**Test lead set, 'Voltage Test Lead, 3-phase + N', included with Fluke 173x, 174x Power Quality Loggers and 3540FC Power Monitor**

**CRITICAL SAFETY ALERT – PLEASE READ!**

**July 2018**

### 174X Series Incorrect 3-Phase Test Lead Connection

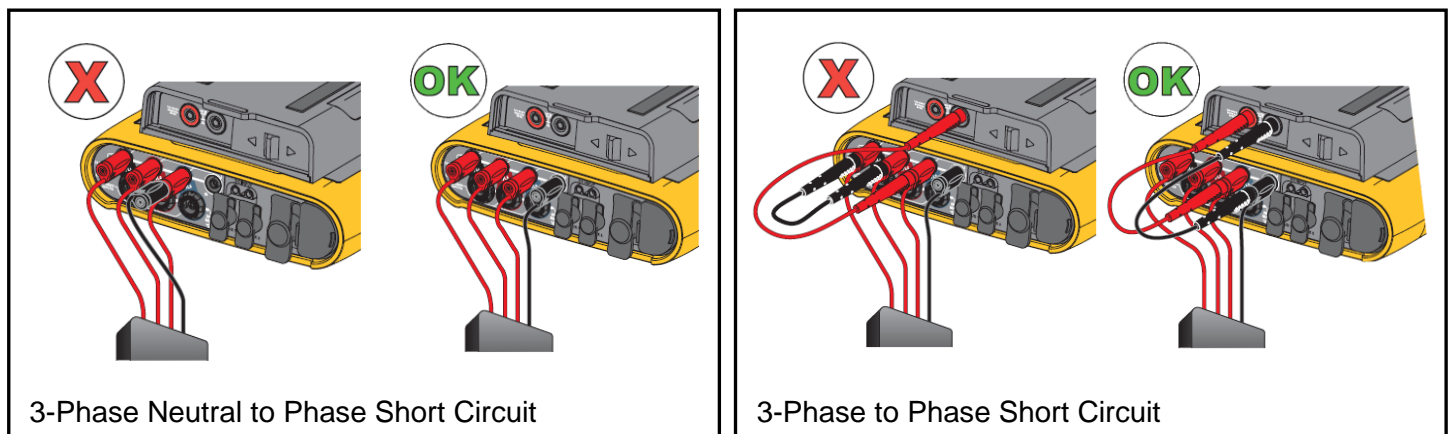
While these test leads are compliant with applicable safety standards, it is possible for a user to miswire the voltage connections on the test lead set when making connections to a Logger. See the diagrams below for examples of miswiring errors.

While the possible wiring errors shown below may seem obvious to trained personnel, if this miswiring were to occur, a phase-to-phase or phase-to-neutral short circuit could result, potentially **causing an arc explosion and posing the risk of serious personal injury or death.**

Examples of possible miswired voltage connections resulting in a short circuit (VOLTAGE CONNECTION ERRORS ARE INDICATED BELOW WITH A RED 'X'):

### **PLEASE USE CAUTION TO AVOID ANY OF THESE MISWIRING CONFIGURATIONS.**

Fluke urges customers to discontinue use of the 'Voltage Test Lead, 3-phase + N' cable set and contact Fluke for a free replacement test lead kit. This replacement test lead kit incorporates straight banana connectors rather than stackable connectors.

Replacement test lead set installed.

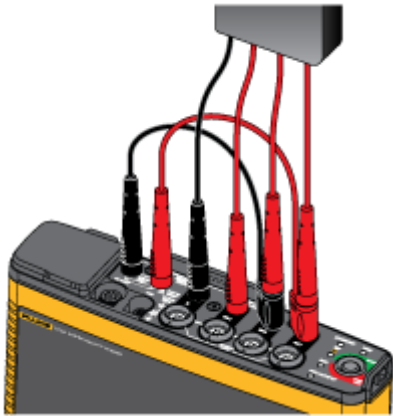
To facilitate powering the Logger from the measurement terminals, the replacement test lead kit additionally includes short jumper accessories with both a stackable connector and a straight banana connector. **The configuration of this replacement test lead kit eliminates the possibility of miswiring the terminals.** See below.
